Ref: LBC/19/00686 – TSD09

MATERIAL SAMPLES CONDITION: CONDITION 2 APPLICATION – SHIREHALL REF: LBC/2019/00686

Please find below photographs taken of the samples of materials proposed for the REPLACEMENT of cleaved / cracked / holed BRICKS (yellow imperial stock), on selected areas to North (rear) and East (left side) facade at the above applicant site:

Plate 4: New stone arrived ready for carving

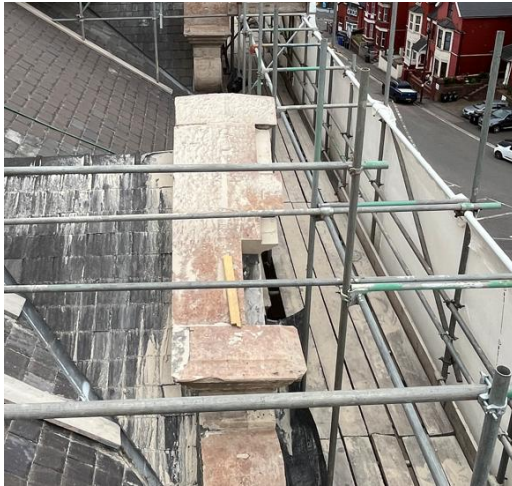
Cleaved, split / holed or defective YELLOW STOCK BRICKS (North and East elevations) of Shirehall are to be replaced using new Witton Fell Quarry Buff sandstone slips (min 50mm thick), pinned with stainless steel rods to existing good stone, bedded on lime mortar with Blaenavon dark lime pointing over to exactly match existing BRICKS in type, colour, dimensions and fit.
